6.1 171-183 FERRARS STREET, SOUTHBANK
LOCATION/ADDRESS: 171-183 FERRARS STREET, SOUTHBANK
EXECUTIVE MEMBER: LILI ROSIC, ACTING GENERAL MANAGER, PLACE STRATEGY AND DEVELOPMENT
PREPARED BY: HELEN PRITCHARD, FBURA PLANNER
SIMON GUTTERIDGE, PLANNING COORDINATOR CANAL WARD

- 1.1 To provide a Council position on Ministerial Application MPA14/0004 for a Section 72 Amendment to the approved permit which authorises Demolition of the existing building and construction of a residential development (20 storey tower), use of the land for dwellings and waiver of loading bay requirements, at the above-mentioned address.

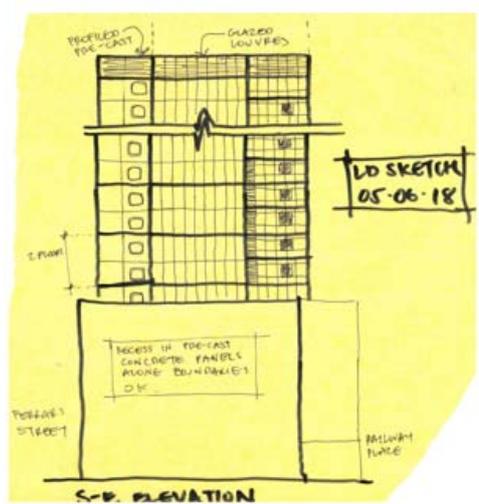
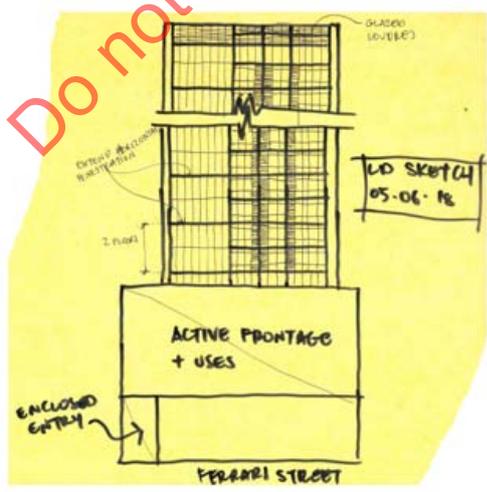
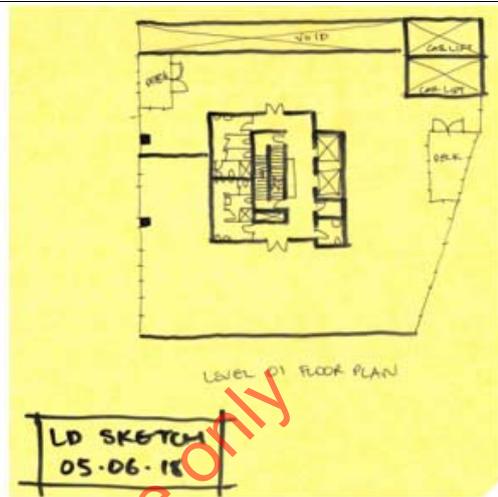
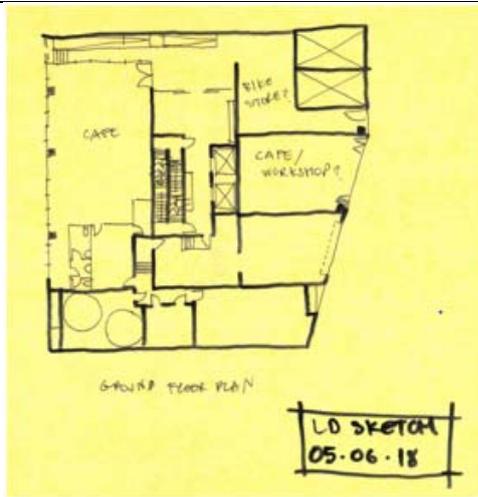
Internal Department / Referral Officer	Referral Comments (summarised)
Urban Design	<ul style="list-style-type: none"> a. Starting from the ground floor – the vehicular access arrangement as proposed off Railway Place is not supported. This creates a poor interface to Railway Place and an enclosed ground floor condition is sought. This could be achieved by investigating the relocation of the car lifts to the North-East corner (refer sketches) which would free up space for more active uses – possibly bike store/workshop/café etc. Secondly this also has the potential to really highlight the car lifts as a feature of the design within the podium. b. The pedestrian link as proposed is also not supported. Ideally, the preference would have been to provide a laneway (or part of) that is open to the sky and doesn't require a vertical change in grade as pedestrians move through the space. Due to site constraints this doesn't appear to be a realistic outcome. As such it is recommended that the entry from Ferrars

<p>Street becomes an enclosed entry space with glazed frontage. This would achieve a strong and defined street edge at ground level which is sought.</p> <ul style="list-style-type: none">c. The provision of commercial use within the podium at level 01 is supported in providing a mix of uses within the Montague Precinct. It is a shame this isn't continued on the levels above to form an active edge to the car park levels – refer sketches.d. Car parking with frontage along the Railway Parade streetscape (despite efforts to conceal it) is not supported, as this would provide a poor inactive frontage and design response to Railway Parade. A better urban design outcome is required which doesn't rely on tacked on screening to achieve visual interest.e. The tower design and façade articulation is generally supported however, there is opportunity to provide a more cohesive design response by extending the horizontal articulation of the grid across at two storey intervals. This would further break up the façade visually and would reflect the expression of a grid at multiple scales – refer sketch elevations.f. Lastly, it is recommended that the louvred screening to the plant floor at the top of the tower is changed to glazed louvres to better integrate it into the design of the rest of the tower. Refer sketch elevations and image of examples.g. Sketches and images referenced within the above comments are provided below:

- a. I've reviewed the provided discussion plans and am satisfied with the changes to façade and materials – I'm extremely pleased they took onboard the feedback.
- b. I express my support of the façade strategy and believe it results in a far more visually cohesive design outcome, particularly with the resolution of the plant louvres.
- c. It is a shame about the Railway Place interface at ground level, however it would overall be a considerable improvement.

- a. The internal pedestrian link has been approved through the original permit and cannot be revisited in principal. While a glazed entrance (automatic sliding doors) could be incorporated into the design to improve the street edge, the original application included an open arrangement and therefore we should not revisit the treatment.

- f. The submitted discussion plans introduce further expressions at regular intervals which would express the building horizontally. The discussion plans also detail the deletion of the bracing structure and introduce glazed louvers to integrate the crown with the rest of the tower. Council's
